GULFWOOD SUBDIVISION, UNIT NO.1, REVISION OF LOT 8 AND ADDITION TO UNIT 1

APPLICATION NUMBER 15 DATE July 11, 2013
APPLICANT Gulfwood, Unit No. 1, Revision of Lot 8 and Addition to Unit No. 1
REQUEST Subdivision

DETAIL SITE PLAN

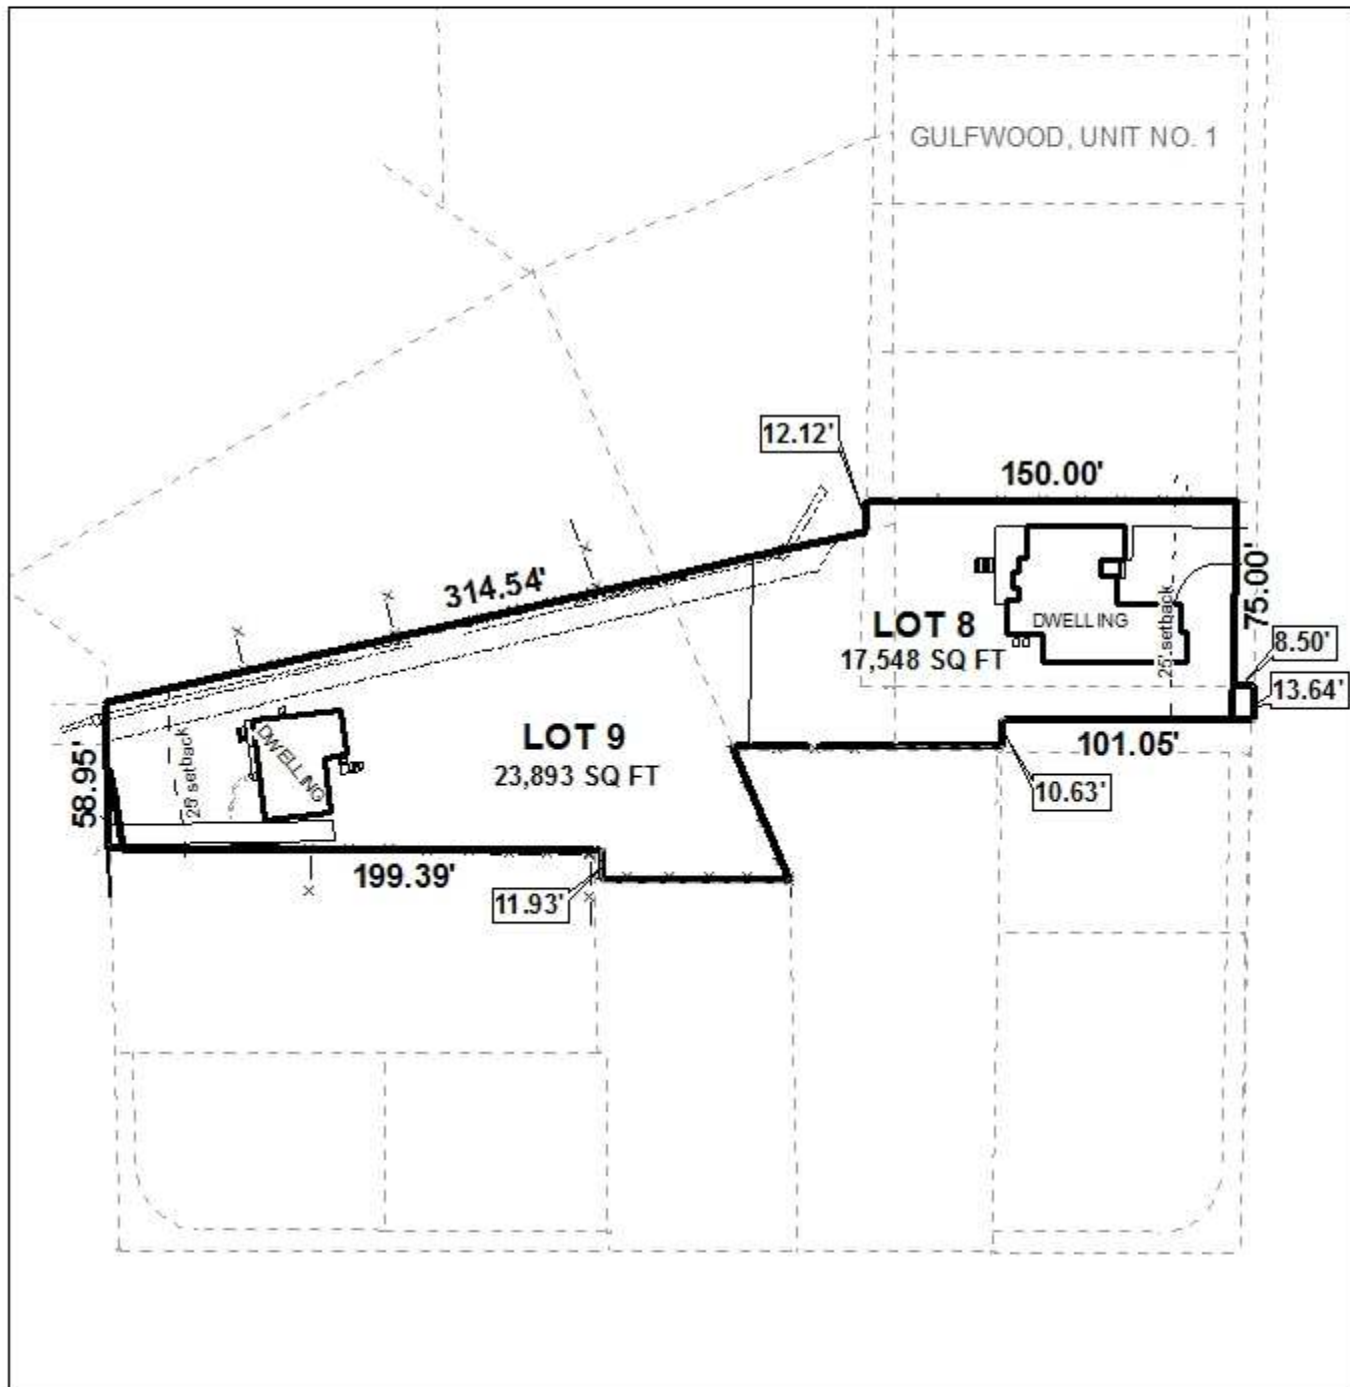
Proposed Lot 8 was developed in 2012. On the site plan submitted at the time for the permit a front setback of 26' was illustrated. The preliminary plat illustrates the house with a front setback at 18.5'; because this encroaches into the 25' required setback, a successful variance to the Board of Adjustment should be required prior to the signing of the Final Plat or Issuance of Certificate of Occupancy.

The proposed lots meet minimum size requirements. The plat however contains several errors; note 4) states, V.A.7 which should be amended to V.A.8 and on note 7) states *Lot 8 and 9 are limited to one curb cuts onto Worth Drive* which should be amended to state Lot 8 and 9 are limited to existing curb cuts onto Wacker Lane and Batre Lane. The legal description is also inaccurate and should be revised before signing of the Final Plat.

- 2) retain 8.5' dedication on Wacker Lane and 5' on the Southwest corner of Batre Lane on the final plat.;
- 3) submission of an application to the BOA to address the front yard setback encroachment on proposed Lot 8, prior to the signing of the final plat or the obtaining of a Certificate of Occupancy;

- 4) revision of note 4) states V.A.7 and should be amended to V.A.8;
- 5) revision of note 7) states that *Lot 8 and 9 are limited to one curb cut onto Worth Drive* and should be amended to state that Lot 8 and 9 are limited to existing curb cuts on Wacker Lane and Batre Lane;
